Type of Report: Committee
Council: 6 August 2018
Expiry Date: 9 August 2018
Application No: PLN-18-19
Address: 26 SWAN STREET , NORTH HOBART
Applicant: Gregory and Rosemary Morgan
93 Salamanca Place
Battery Point
Proposal: Partial Demolition, Alterations and Multiple Dwellings
Representations: Two (2)
Performance criteria: Inner Residential Zone Development Standards, Road and Railway Assets Code, Parking and Access Code, and Historic Heritage Code

1. Executive Summary

Figure 7: The proposed site plan showing the location of Dwellings A and B.

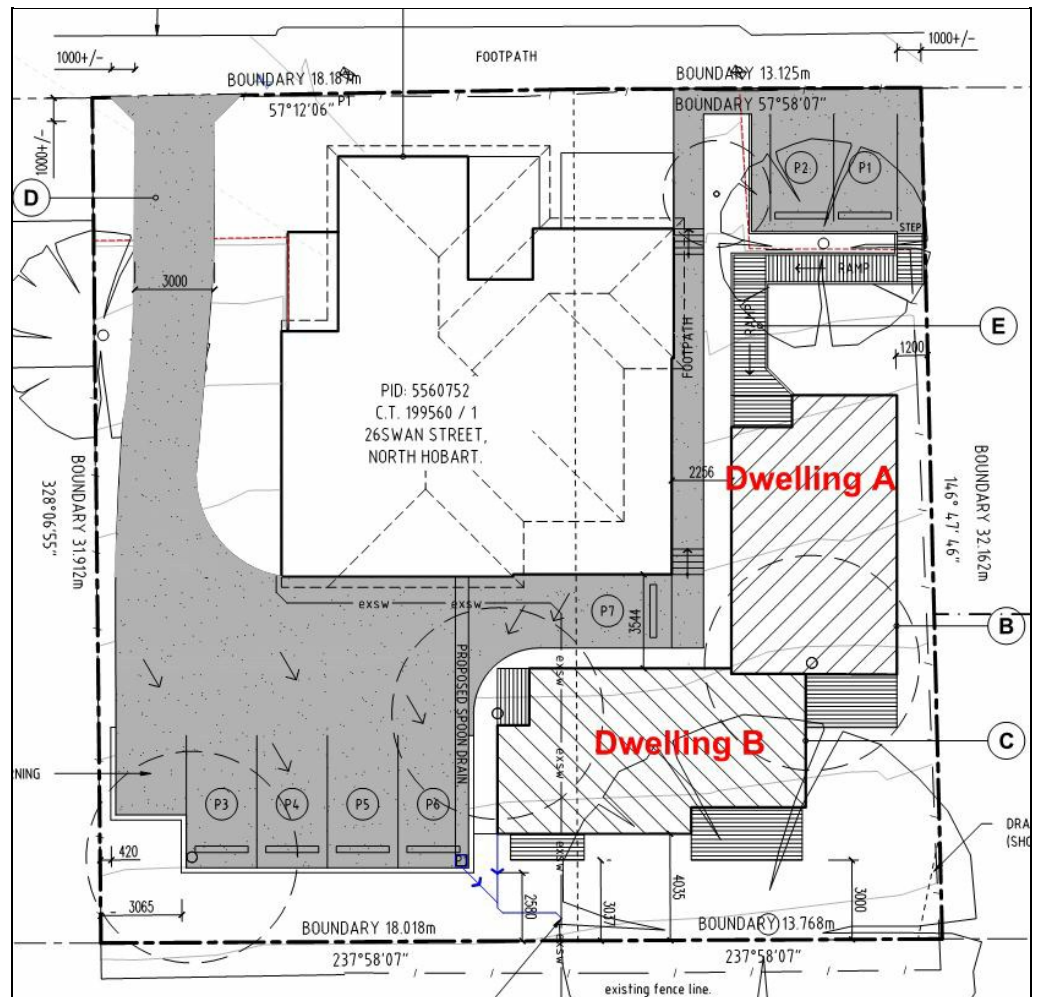
6.7.2 The proposal includes Dwelling A having a maximum wall height of 7.47m at a setback of 1.2m from the north eastern boundary, Dwelling B having a maximum height of 7.1m at a setback of 5m, and 7m at 4m from the rear boundary, and a car parking deck with a maximum finished surface level of 1.2m, and a vehicle crash barrier 1m above this at a setback of 2.58m from the rear boundary.

Figure 8: Demonstration of the extent of Dwelling A that is located outside of the building envelope.

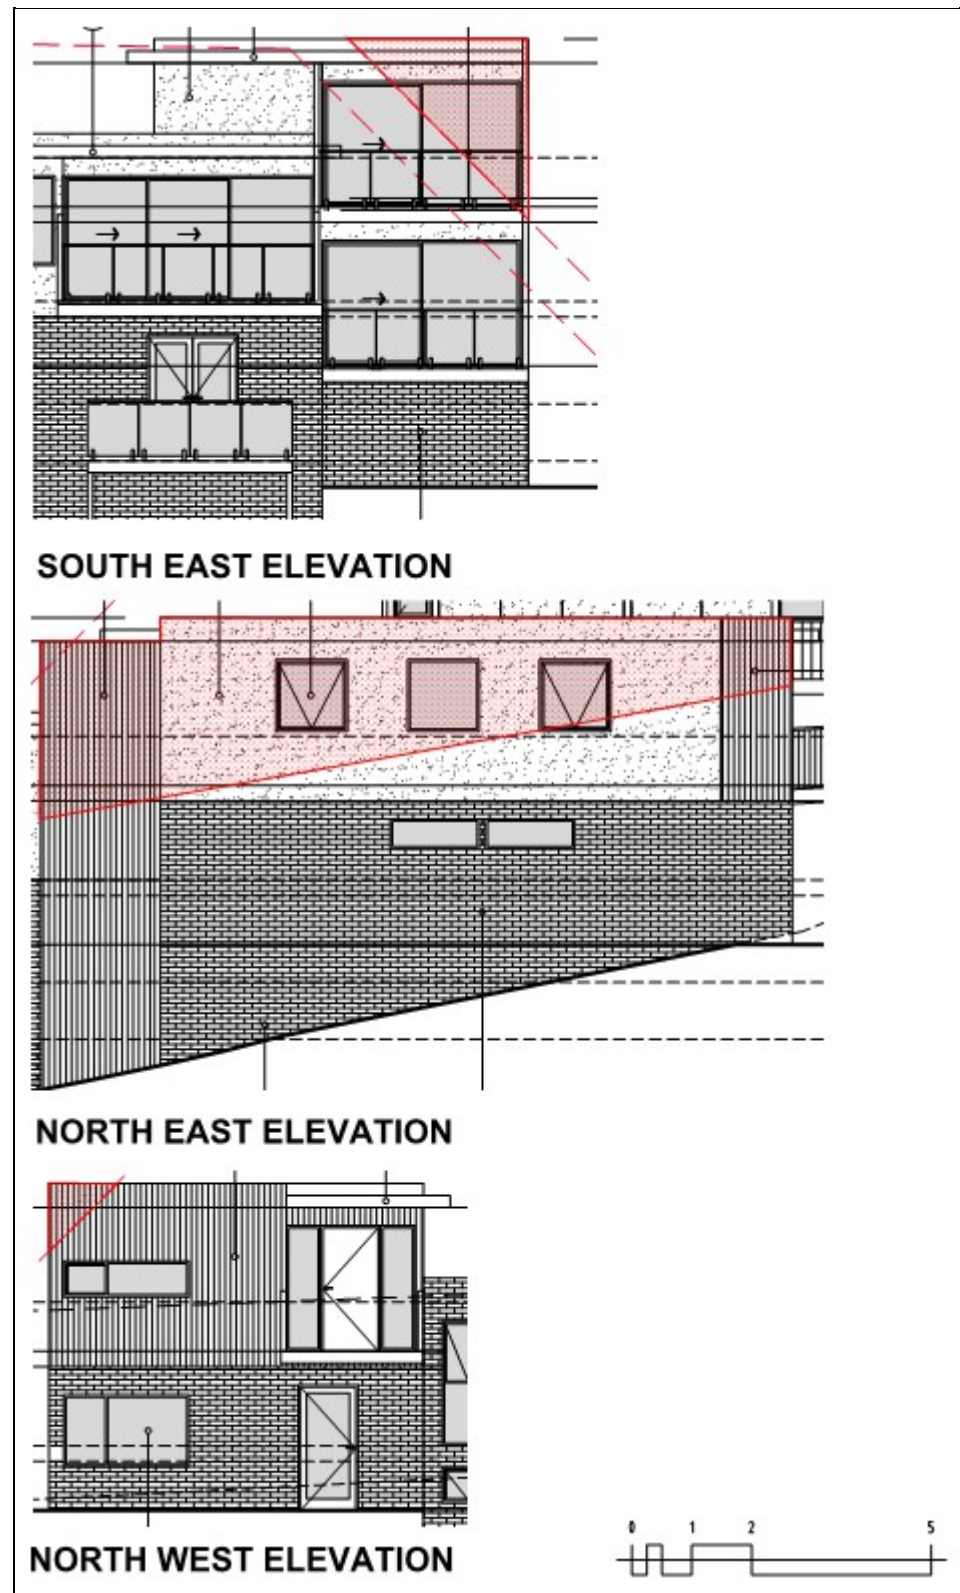
- 6.7.5 The extent of the dwelling that is outside the building envelope for Dwelling A is shown in figure 8 below.

Recent Tribunal decisions, including *The House Family Office Pty Ltd v Hobart City Council*, have determined that when assessing an application against the performance criterion, reference must not be had to the building envelope authorised by the acceptable solution. That is, the permitted building envelope does not provide the test of 'reasonableness' against which a discretionary application is assessed. Instead, the development must be assessed on its merits against the provisions of the performance criterion; that is, (a) does the development cause an unreasonable loss of amenity to neighbours by reduction in sunlight to a habitable room (other than a bedroom), overshadowing of private open space, or visual impacts caused by the apparent scale, bulk or proportions of the dwelling when viewed from an adjoining lot, and (b) does the development provide separation between dwellings on adjoining

Dwelling A is located to the south west of the adjacent dwelling at 24 Swan Street. As such, it will not cause any unreasonable loss of sunlight or overshadowing to that dwelling.

The facade of Dwelling A contains various materials and finishes, as well as several windows in the upper level, to help break up the visual bulk. However, a reduction of height for the privacy screen on the north eastern side of the south eastern, upper level rear deck would assist in giving the appearance of stepping the new building down the site when viewed from the adjacent property at 24 Swan Street. As such, were Council to support the application, it would be recommended that a condition be included in the permit reducing the maximum height of the screen to 1.8m above the finished floor level of the deck.

Swan Street has a mixture of separations between dwellings, ranging from a large number of dwellings with very limited separation, to the dwellings at 24 and 26 Swan Street which have an unusually large separation, in the context of the street. The dwellings in Newdegate Street are situated on less regular lots, and are less uniformly situated within these lots, making a uniform, identifiable separation difficult to quantify. The proposed new dwelling will retain an above average separation between it and the adjacent dwelling at 24 Swan Street, whilst providing a separation comparable to others in the street for the buildings on the site.

Figure 9: Demonstration of the extent of Dwelling B that is located outside of the building envelope.

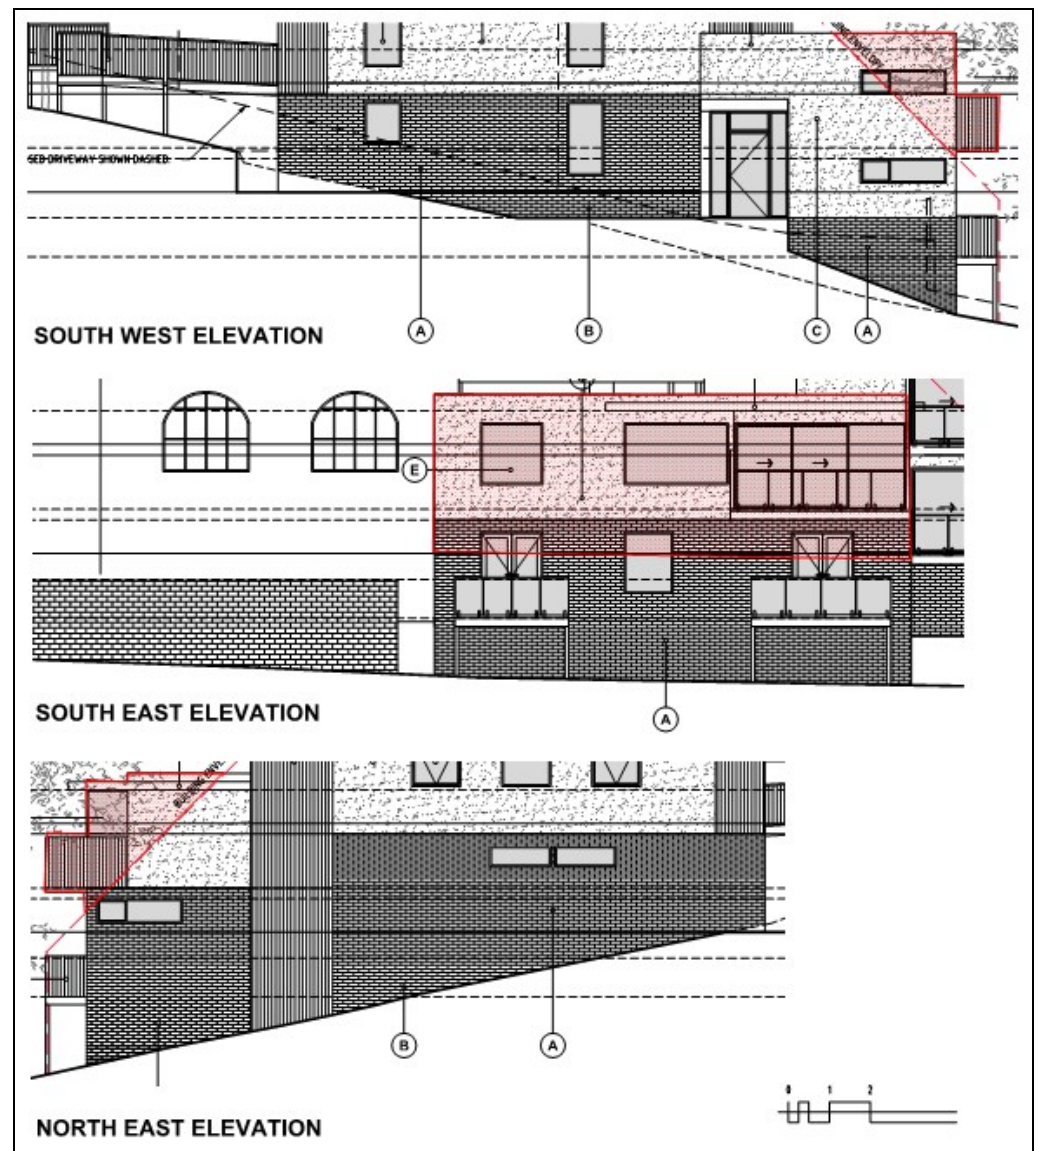
- 6.7.6 The extent of the dwelling that is outside the building envelope for Dwelling B is shown in figure 9 below.

Again, in light of recent Tribunal decisions, the key questions for Dwelling B are (a) does it cause an unreasonable loss of amenity to neighbours by reduction in sunlight to a habitable room (other than a bedroom), overshadowing of private open space, or visual impacts caused by the apparent scale, bulk or proportions of the dwelling when viewed from an adjoining lot, and (b) does it provide separation between dwellings on adjoining lots that is compatible with that prevailing in the vicinity?

There will be some afternoon shading of the rear yard at 27 Newdegate Street from the proposed new dwelling. There will be a small amount of morning shadow to the rear of the dwelling at 1 Lower Jordan Hill Road in the morning, but there will still be sunlight to the rear of the dwelling from midday into the afternoon. There will be increased morning shading to the rear yard of 28 Swan Street from the rear dwelling. The bulk of the overshadowing from Dwelling B will be over the rear yard at 33 Newdegate Street. However, the dwelling is located sufficiently forward on the lot that there will still be sunlight to the private open space.

The rear of proposed Dwelling B has various materials, windows and three small decks which will break the massing of the building and ensure that the visual bulk is not unreasonable when viewed from the adjacent properties to the south east.

Swan Street has a mixture of separations between dwellings, ranging from a large number of dwellings with very limited separation, to the dwellings at 24 and 26 Swan Street which have an unusually large separation, in the context of the street. The dwellings in Newdegate Street, are situated on less regular lots, and are less uniformly situated within these lots, making a uniform, identifiable separation difficult to quantify. The proposed new dwelling will retain an adequate separation from the rear boundary to be generally in accordance with others in the area.
